*AS BUILT - 2-5-80 RPH

CITY OF RIVERSIDE
PUBLIC WORKS DEPARTMENT

SIDEWALK CONSTRUCTION
AT VARIOUS LOCATIONS

R-2174

△ DETAIL V
(UNDER SIDEWALK DRAIN)
N.T.S.

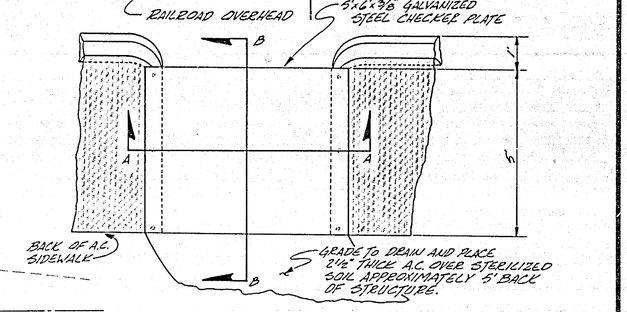
1. FROM END OF EXISTING CURB SIDEWALK APPROX. 700 FT. N/W'LY OF ARIZONA, TO BEGINNING OF EXISTING TYPE I BERM APPROX. 500 FT. SE'LY OF INDIANA, USE DETAIL III.
2. TRANSITION FROM EXISTING CURB AND SIDEWALK TO DETAIL III SECTION SHALL BE AT LEAST 60' IN LENGTH.
3. △ ~~PLACE 10 LF. OF 8" SMOOTH BORE PIPE IN SAG ABOUT 1350 LF. N/W'LY OF ARIZONA. INLET AND OUTLET CONDITIONS FOR THIS PIPE WILL BE ADAPTED IN THE FIELD.~~ (SEE DETAIL V)
4. TRANSITION BETWEEN DETAIL III AND DETAIL IV SHALL BE AT LEAST 5' IN LENGTH.
5. FROM APPROX. 500 FT. SE'LY OF INDIANA TO INDIANA USE DETAIL IV.

MARK	REVISIONS	APPR	DATE
△	8" PIPE REPLACED BY STRUCTURE SHOWN IN DETAIL V	W.L.	7/20/79
